Technical Bulletin 252

07.2025

Item:	252.1
Description:	Triumph Diagnostic Tool - ABS Calibration Update and Smart Scan ABS Calibration Version Check Improvement
Model Affected:	Speed Twin 900 from VIN CC4121, Speed Twin 1200 from VIN CB9662 , Speed Twin 1200 RS from VIN CB9979, Trident 660 from VIN CB1390, Trident 660 Triple Tribute from VIN CH8328, Trident 660 LAMS from VIN CC8450, Tiger Sport 660 from VIN CC1223, Tiger Sport 660 LAMS from VIN CD4484, Tiger Sport 800 from VIN CD4171

Description: Triumph Diagnostic Tool - Replacement ABS Modulator Setup - Change to ABS Variant Code Configuration Process

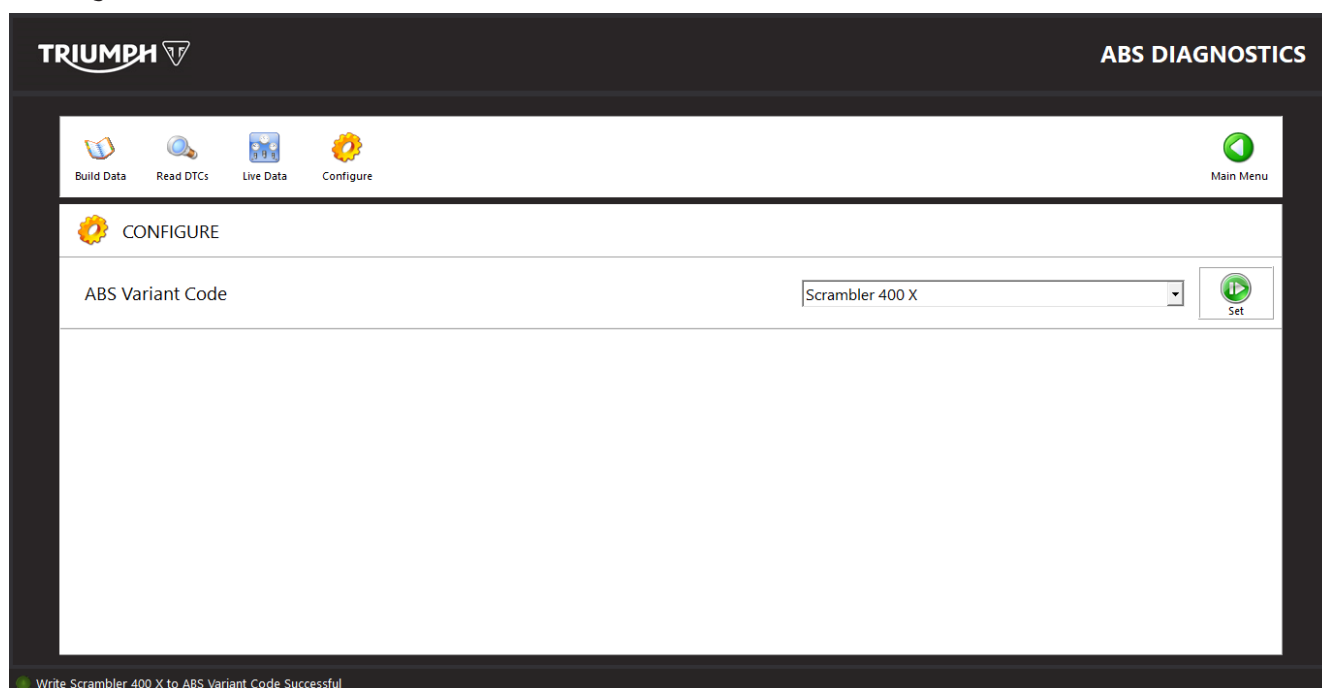
- The Configure ABS Variant Code feature provided in the ABS Diagnostics area (pictured below) will no longer be available for the above models.

- Instead, ABS Variant Code configuration will be checked and performed as part of the Smart Scan Summary and Download process.
- In addition, Smart Scan identification of the above models will be locked to the motorcycle VIN read from the Engine ECM. This ensures VIN based allocation of all ECM calibration files for download.
